# REFERRAL DOCUMENT

To be filled in by a Planner	
Application No.	PDPL/00817/2022
Address	146, 148 & 150 BRIDPORT STREET ALBERT PARK VIC 3206
Zone	
Overlay	HO443 significant buildings
Proposal Summary	
Relevant Documents	
Specific information sought by the planner

## Heritage Advisor response:

## Urban Design Referral

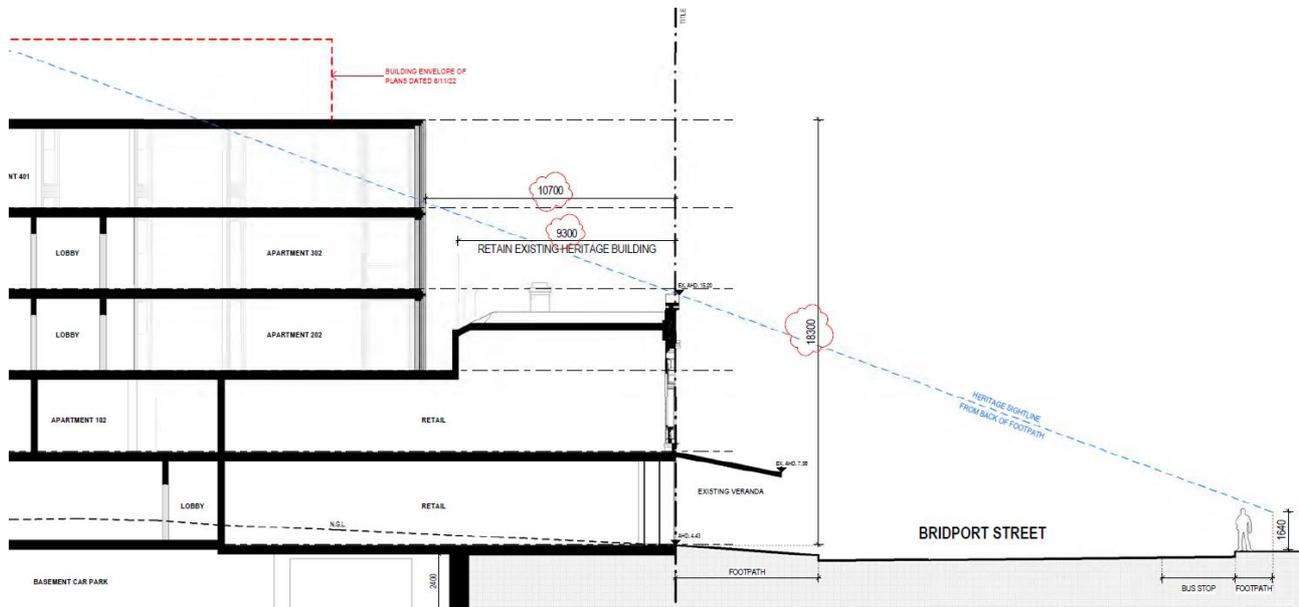
The option B detailed above will not be supported by Council as it is contrary to Council policy to remove significant fabric and replace it with fabric from another place. The plans do not show any demolition or change to shopfront 146, and no previous support has been given for this proposal.

The glass, metal and tile Inter-war shopfront at number 146 is not original to the building, is a later addition and possibly was installed at the same time as the removal of a section of verandah above number 146. The shopfront is still significant and is of a quality and intactness that warrants its retention. Changes to retail spaces is a normal part of the history of commercial buildings as new technology and materials were introduced and shopping trends changed. This history of changing shopfront styles is reflected in the two different shopfronts at 148 and 146 and should be retained.
